Addendum 2
Solicitation # 26-99324
West Superior Street Reconstruction

WEST SUPERIOR STREET RECONSTRUCTION
 DULUTH, MINNESOTA S.P. 118-109-021/CITY PROJECT NO. 2104

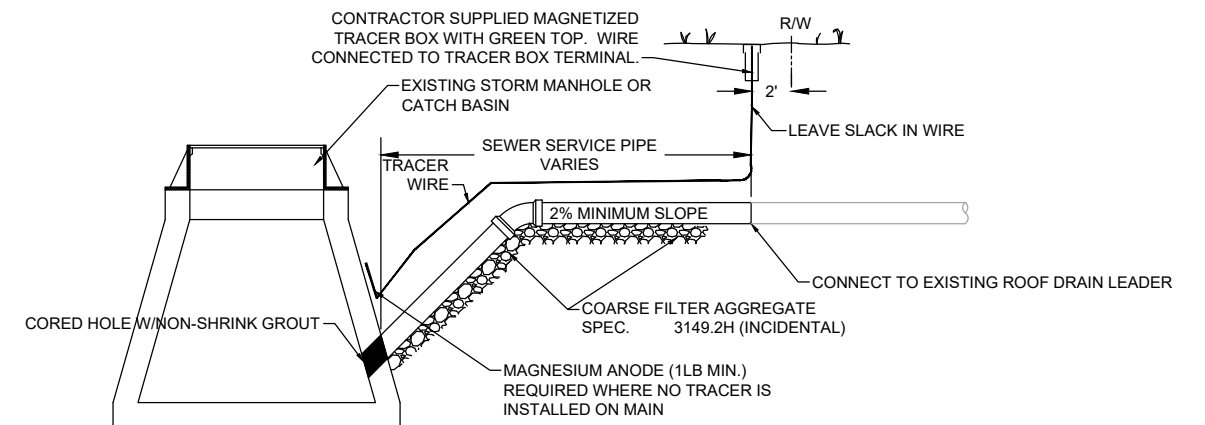
9. Plan detail shows vault fill at 18" lifts with minimum wait time between pours of 72 hours. Specials say 3' lifts once per calendar day. Safe to assume the special provisions take precedence over the drawings?

The detail on sheet 96 is correct. SP-56 has been updated in this addendum to be consistent with detail.

CONSTRUCTION DETAILS

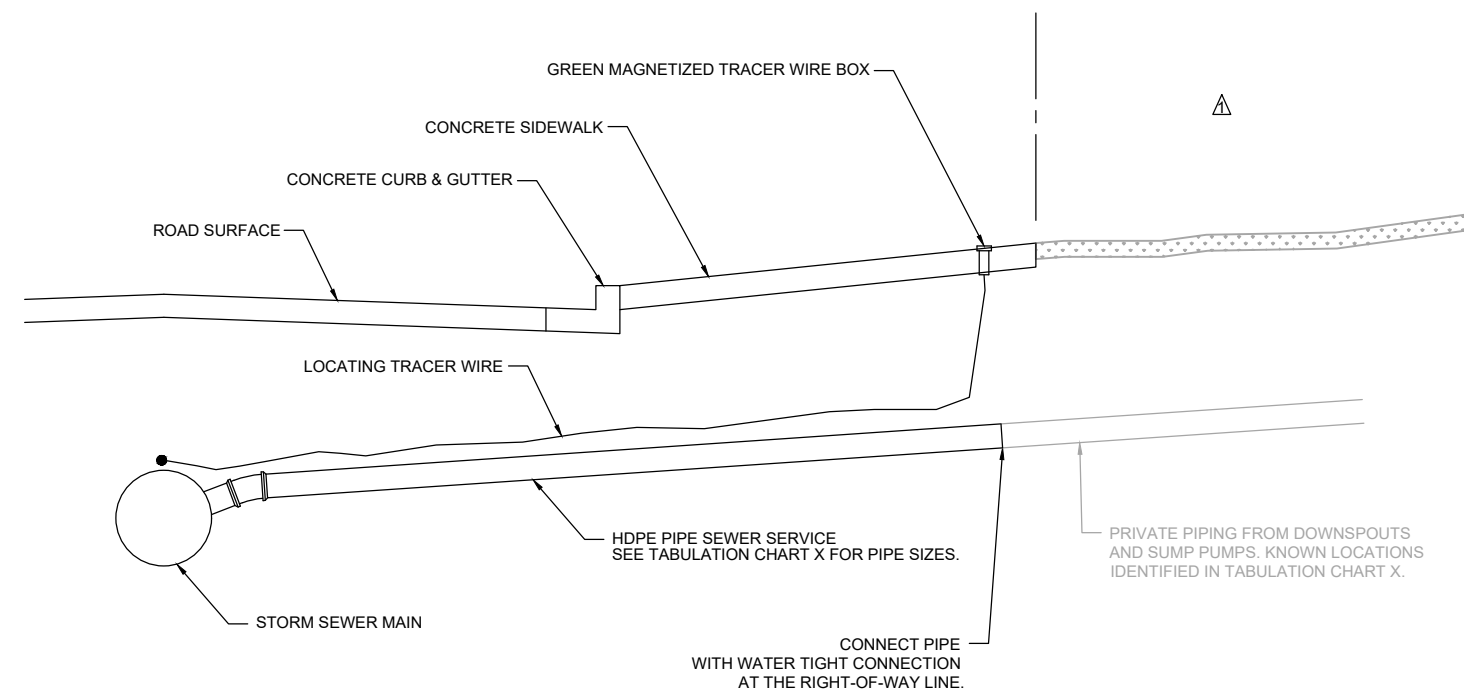
1. Drawing changes to the CONSTRUCTION DETAILS are as follows:
 - a. Sheet 79; Delete Sheet 79 in its entirety and replace with revised Sheet 79. Revisions to Sheet 79 are as follows:
 - i. Pipe sizes are clarified.

3. Sheet 79 connect to existing roof drain calls out existing 4" PVC installed during construction on the connect to existing roof drain leader detail. Is the installation of the PVC pipe and connection to the proposed storm sewer incidental to the connection to existing roof drain lead. If so, what City of Duluth detail represents the required connection type to the proposed storm sewer.

Both details are included and will be used depending on the situation shown in the plans, see sheet 214 for an example using the connect to catch basin detail while the ones on the south side of the road on sheet 223 will connect to the pipe. The required pipe sewer is a separate pay item shown on Chart X on sheet 62 and is the only item required for the complete connection that is not included in payment of this item. The connection type is also listed on this chart. The detail on sheet 79 is updated to reference the pipe size in Chart X, which will govern the pipe size unless the existing pipe is a different size and the Engineer directs a different size. Connection to the proposed storm sewer is incidental to the connection to existing roof drain leader.
